Customer Notification

B-CN-472-EN REV A

SUBJECT: I/O Board LED Color Indication

Figure 1: Power LED

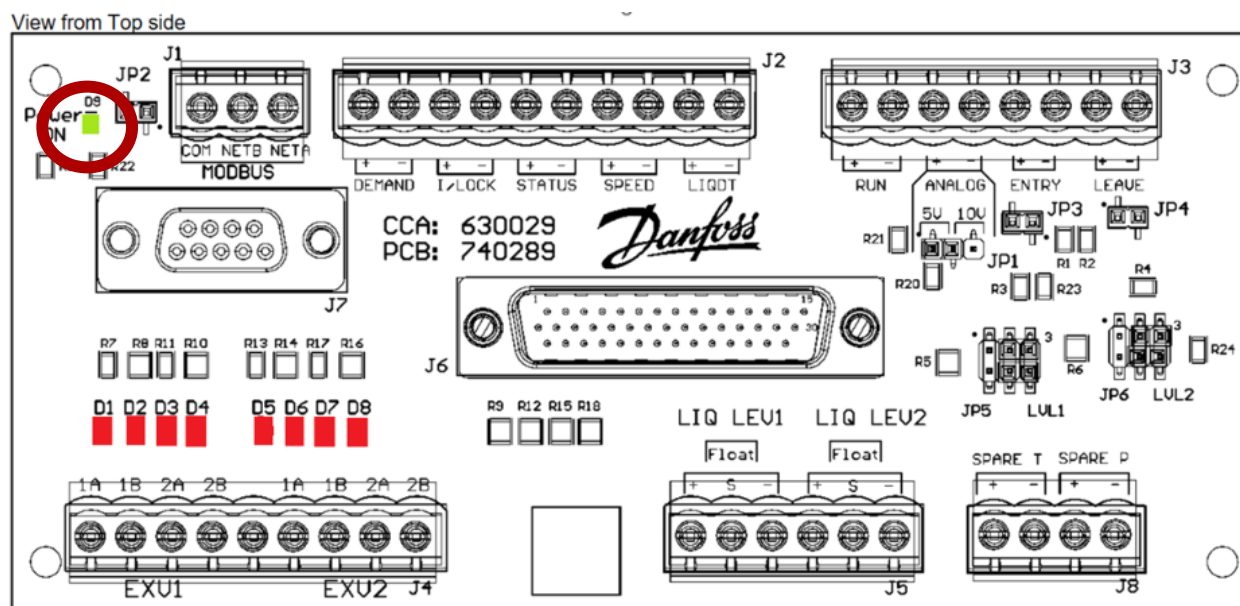
The affected I/O Boards may display a red LED indication instead of the expected green indication for compressor status as indicated at LED Location D9 in Figure 1. In some cases, the LED indication associated with the EXV drivers indicated at LED Locations D1-D8 may also differ from the expected color and display a green LED indication instead of the expected red indication as shown in Figure 2.

No proactive replacement of the I/O Board is required. Customers do not need to replace I/O Boards solely because the LED colors differ from the standard color indication. If a customer identifies an I/O Board with the described LED color variation and requests a replacement, Danfoss has replacement I/O Boards available for shipment.

Figure 3: I/O Board SN Location

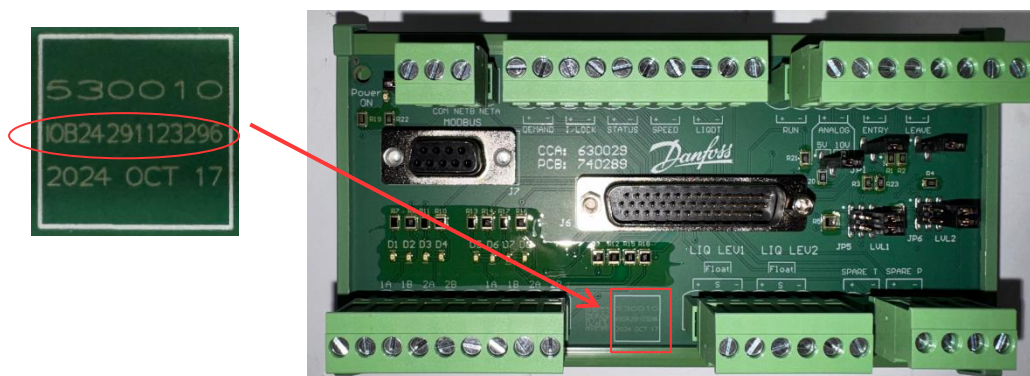
The I/O Board serial number can be identified at the location shown in Figure 3. The first eight characters of the I/O Board serial number can be used to determine whether the board is associated with the identified LED color variation.

Customers should contact their Danfoss Turbocor Compressors representative with the I/O Board serial number so that the condition can be verified, and a replacement I/O Board can be provided as appropriate.
